SNL09
NEW MEXICO
ENVIRONMENT DEPARTMENT

**RE: NOTICE OF DISAPPROVAL: DOE/SANDIA RESPONSES TO NMED'S
NOTICE OF DISAPPROVAL FOR CORRECTIVE MEASURES EVALUATION
REPORT FOR TECHNICAL AREA-V GROUNDWATER, JULY, 2005
SANDIA NATIONAL LABORATORIES
EPA ID# NM5890110518
HWB-SNL-05-027**

As Appendix A of the response, the Permittees submitted: *Technical Area V Groundwater Investigation Work Plan, Installation of Groundwater Monitoring Wells TAV-MW11, TAV-MW12, and TAV-MW13, Installation of Soil-Vapor Monitoring Wells TAV-SV01, TAV-SV02, and TAV-SV03*, dated April, 2009 (hereinafter referred to as the Work Plan). NMED has the following comments regarding the Work Plan.

**Figure 2. TAV-MW1/MW10
TCE and Nitrate**

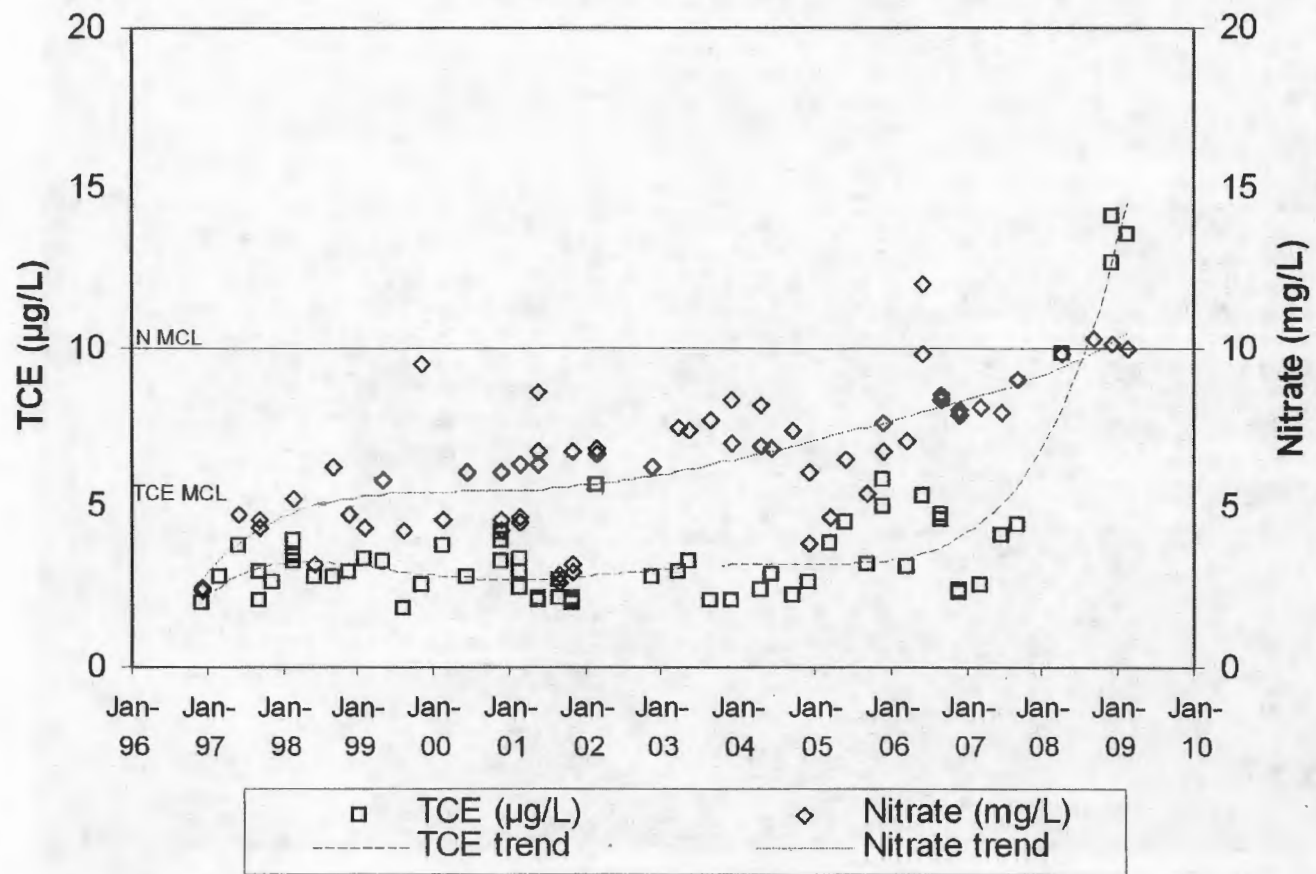
Groundwater at TAV-MW10 exhibits TCE above the maximum concentration limit (MCL) and has an increasing nitrate-concentration trend suggesting that nitrate levels are beginning to exceed the MCL (see Figure 2 enclosed with this letter). This well can therefore no longer be used to delineate the outline of the plume (i.e., the area of the plume where concentrations are below MCLs). Another well is needed to characterize the plume in this area of Technical Area – V (TA-V). Even if groundwater samples from TAV-MW11 and TAV-MW12 are nondetect with respect to TCE and nitrate, TAV-MW10 would show the plume outline is not resolved. A suggested location for this additional well is shown in Figure 1 of this letter.
